UNITED STATES PATENT AND TRADEMARK OFFICE

APPLICATION NO.	FILING DATE	FIRST NAMED INVENTOR	ATTORNEY DOCKET NO.	CONFIRMATION NO.
10/632,758	08/01/2003	Akram Ali	706513US1	4650

Office Action Summary

DETAILED ACTION

FIG. 1

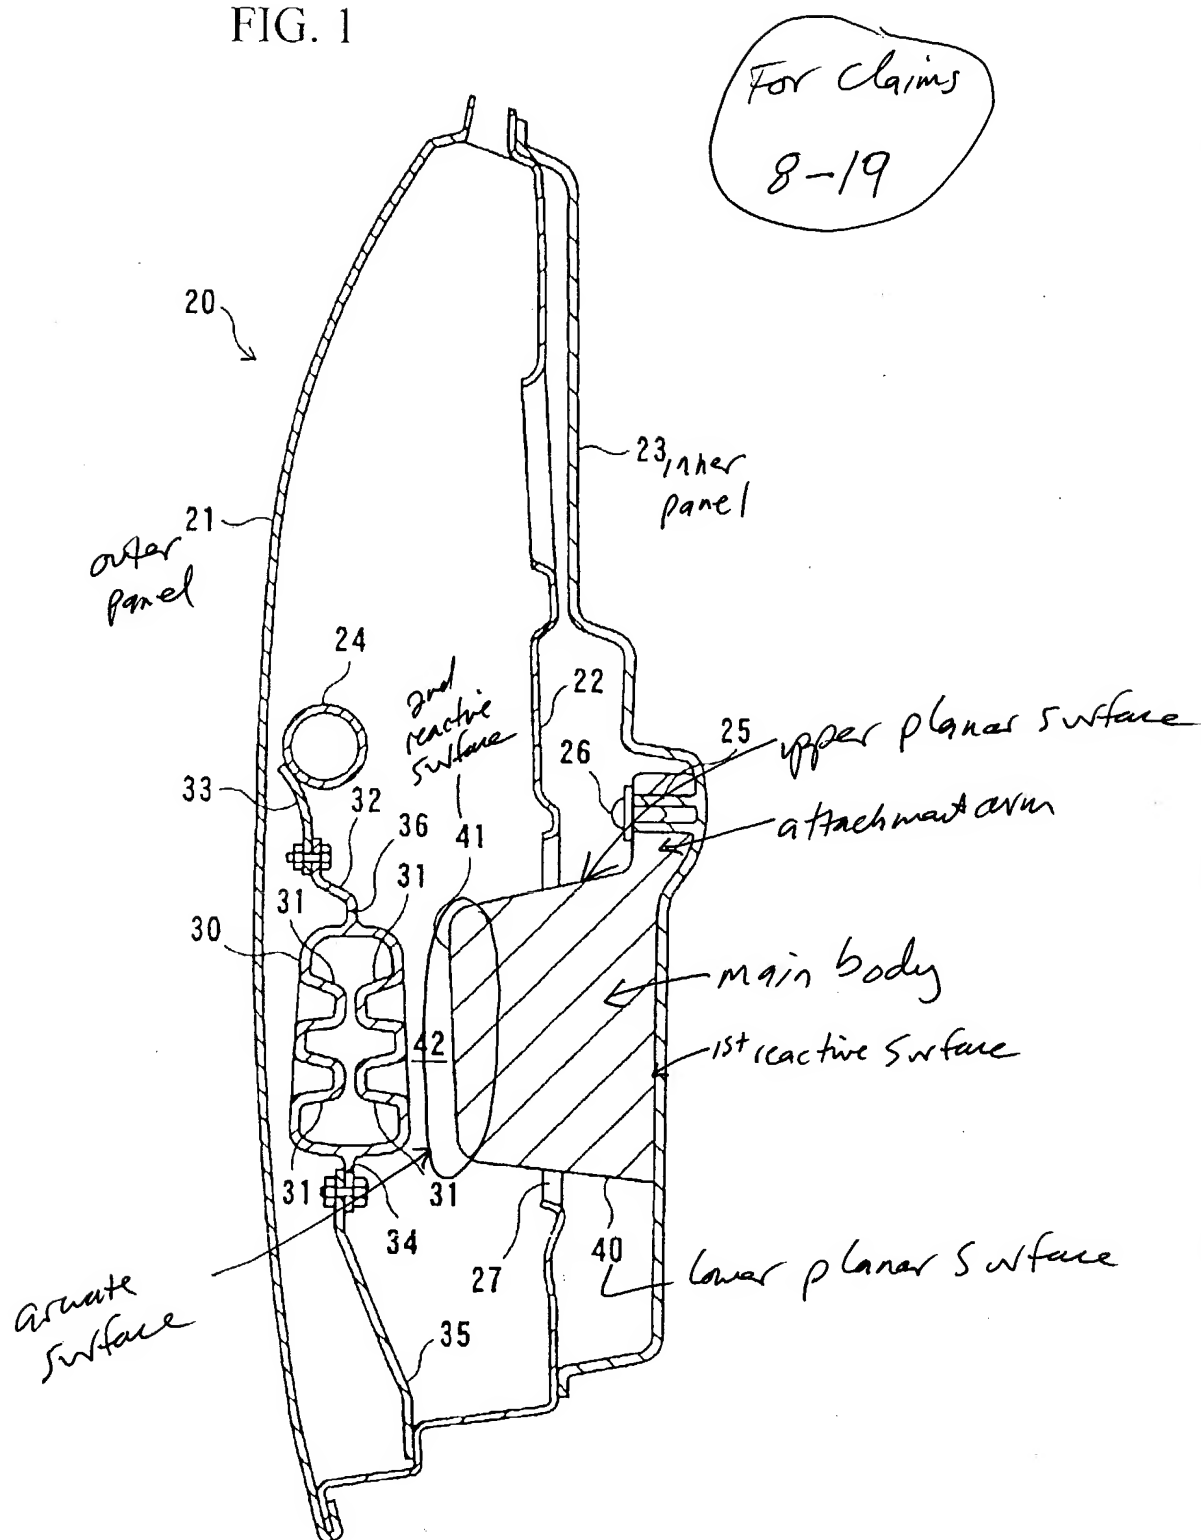
5. Claims 1-17, as understood, are rejected under 35 U.S.C. 102(e) as being anticipated by Fukutomi.

Fukutomi discloses the claimed invention as shown in the marked up copies of Figure 1 attached hereto. Note that there is one marked up copy for claims 1-7 and one marked up copy for claims 8-14. Regarding claims 7 and 14, the main body is considered to be relatively rigid in that it is described in column 3, lines
